**SUBDIVISION COMMITTEE
METROPOLITAN AREA PLANNING COMMISSION**

STAFF REPORT

(Final Plat, Preliminary Plat Approved 3/31/94)

CASE NUMBER: S/D 94-19 EBERSOLE ADDITION

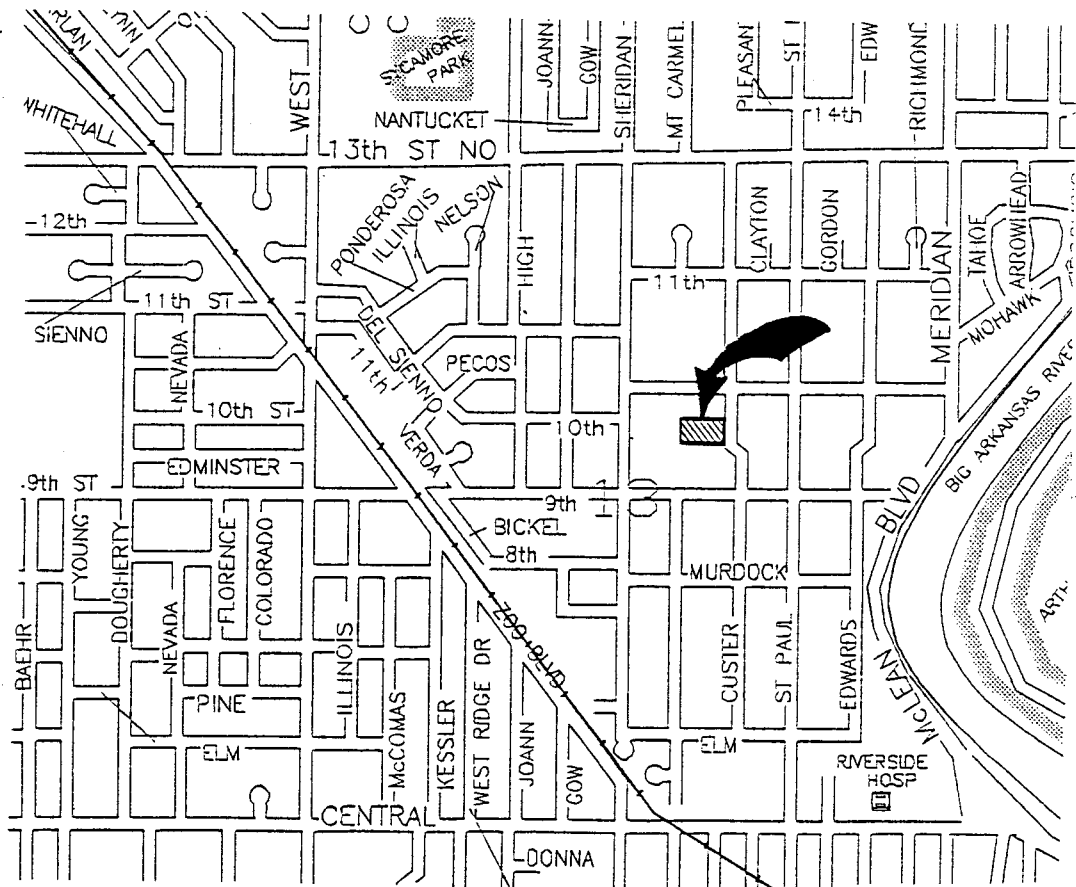
- D. On the final plat tracing, the setback on Lots 2 & 3 to Custer Court should be labeled as building rather than garage setbacks. For Lots 1 & 2, a note should be placed on the face of the plat explaining that the "garage" setback to Custer Court does not apply to main structures or other uses but only garages. That is, the house is restricted by Zoning or other platted conditions such as the 15' street-drainage-utility easements.

- E. The applicant shall submit a covenant which provides for four (4) off-street parking spaces per dwelling unit on each lot which abuts a 32-foot street. The covenant shall inventory the affected lots by lot and block number and shall state that the covenant runs with the land and is binding on future owners and assigns. It should be noted that this requirement further highlights the need to assure adequate driveway lengths are provided for such off-street parking.

- F. Since this plat proposes the platting of narrow street right-of-way with adjacent "15-foot street, drainage and utility easements," a restrictive covenant shall be submitted which calls out restrictions for lot-owner use of these easements. Retaining walls and change of grade shall be prohibited within these easements as well as fences, earth berms and mass plantings. Any plantings within the easement shall be reviewed by the City Forestry Division prior to installation.

- G. On the final plat tracing, the 3rd line of the plattor's text should be revised to note that the site is being platted into lots.
- H. The applicant is reminded that an updated platting binder must be submitted for this site and that this plat will be subject to a review of this binder and will be subject to any applicable conditions of such a review.

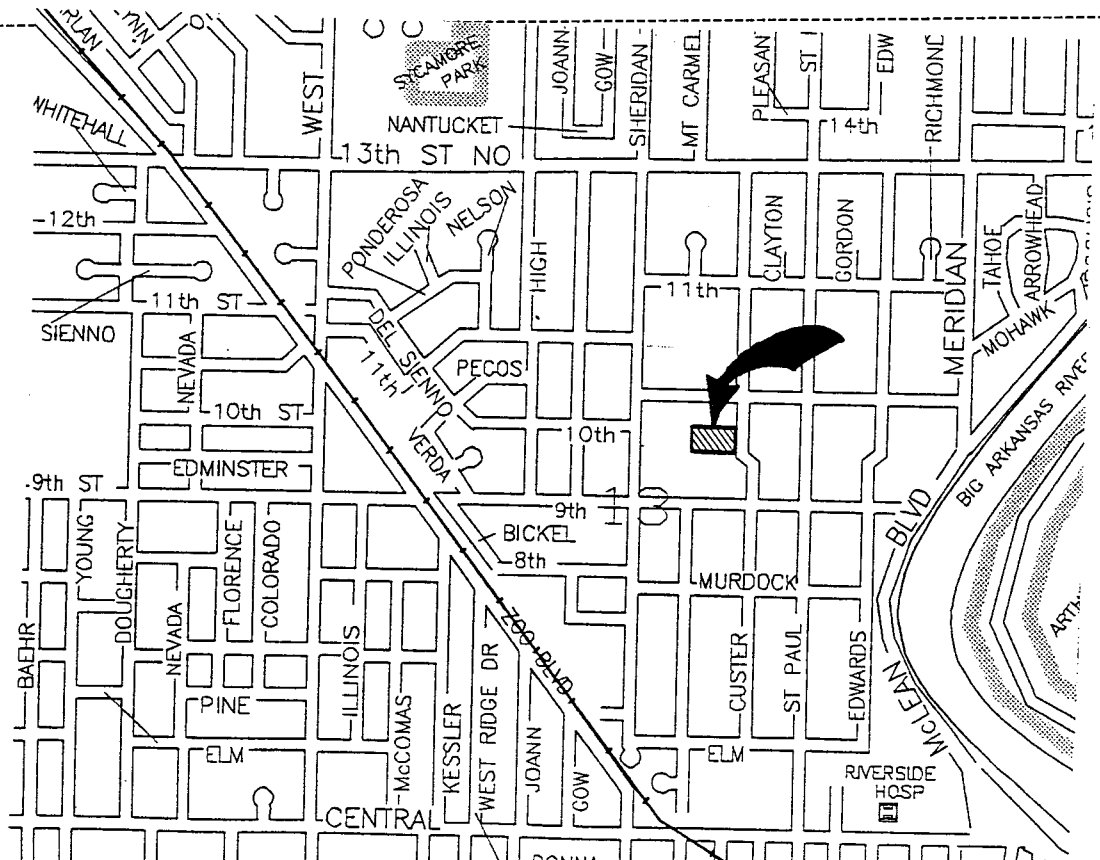
- A. This area is typical of earlier residential development patterns that occurred with long lots and wide blocks. In certain cases these blocks have been replatted such that a street was created in the middle of the previous block and new building sites were created out of the previous rear portions of the preceding lots. In other cases, streets have been created a piece at a time by means of lot splits, replats of individual lots or even street dedications by separate instrument.

In order to allow for the future development of a street through the center of the block in which this site is located, 30-feet of right-of-way shall be dedicated from the western end of this plat. Also, 5-feet of right-of-way shall be dedicated along this plat's east end for what is now the substandard 50-foot right-of-way for Custer.

- B. The applicant shall guarantee the extension of City water to serve the lots being platted.
- C. The applicant shall guarantee the paving of the narrow public streets to the 29-foot paving standard. The applicant is advised that for short culs-de-sac, such as shown on this plat, turnarounds other than circular may be considered.

- F. Although this plat indicates on Lots 1 and 4, a 25-foot building setback to Custer, the shape of these lots implies that homes and garages may be fronted to the court. With only a 32-foot right-of-way for the court, almost all of the right-of-way will be involved in pavement and curb and gutter. That is, this type street does not have the typical 14.5 foot grass area between curb and property line. With only a 15-foot street drainage utility easement or building setback, any garage facing the Court could have a driveway too short to keep a normal length car, if parked on it, from projecting over the paved street area.

This plat therefore needs to establish a setback to the Court of at least 20-feet for any garage that could be fronted to the Court or, restrict garages so as to front Custer Street. Prior to submitting the final plat, the applicant shall meet with Planning to determine how such a control can be provided.
